Access Compliance Report
Public Rights-of-Way
(Curb Ramps)

Main Street: LIGADO_ST | **Cross Street:** FORMERO_ST | **Location:** NE

ADA ID: RPRK211119121125 | **Ramp Type:** Type 4 - Parallel | **Initial Pass/Fail:** Fail | **Overall Compliance:** No | **Severity Score:** 2

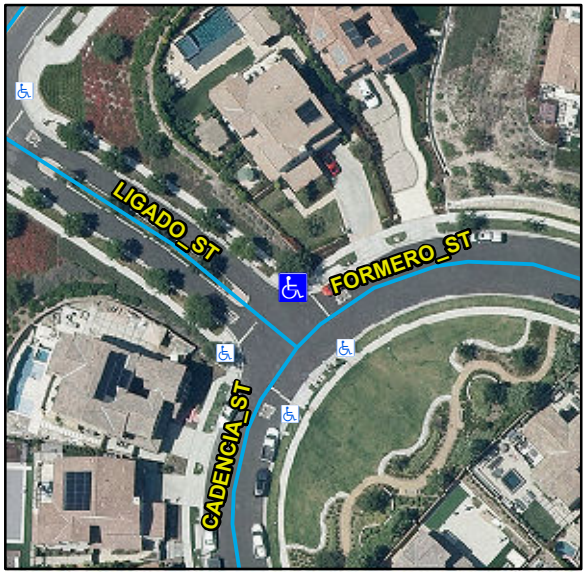
Compliance	Description	Data	Compliance	Description	Data
N/A	Ramp Length LT (in)	**64**	**N/A**	Ramp Length RT (in)	**133**
Yes	Ramp Width LT (in)	**54**	**Yes**	Ramp Width RT (in)	**54**
Yes	Ramp Run Slope LT (%)	**5.3**	**Yes**	Ramp Run Slope RT (%)	**8.2**
Yes	Ramp Cross Slope LT (%)	**1.9**	**No**	Ramp Cross Slope RT (%)	**2.4**
N/A	Landing Present	**N/A**	**N/A**	DWS Provided	**N/A**
N/A	Landing Length (in)	**N/A**	**N/A**	DWS Contrast	**N/A**
N/A	Landing Width (in)	**N/A**	**N/A**	DWS Length (in)	**N/A**
N/A	Landing Run Slope (%)	**N/A**	**N/A**	DWS Full Width	**N/A**
N/A	Landing Cross Slope (%)	**N/A**		DWS Offset Type	**N/A**
N/A	Landing Movement Obstructed?	**N/A**	**N/A**	DWS Offset Left (in)	**N/A**
	Landing Movement Type	**N/A**	**N/A**	DWS Offset Right (in)	**N/A**
N/A	Landing Shared	**N/A**			
N/A	Clear Space	**Yes**			
N/A	Clear Space To Crosswalk (in)	**N/A**			
N/A	Marked Crosswalk 1	**No**	**N/A**	Marked Crosswalk 2	**No**

Remove & Replace Curb Ramp With Two New Directional Ramps or Equivalent.

R304.5.3, STD 1115
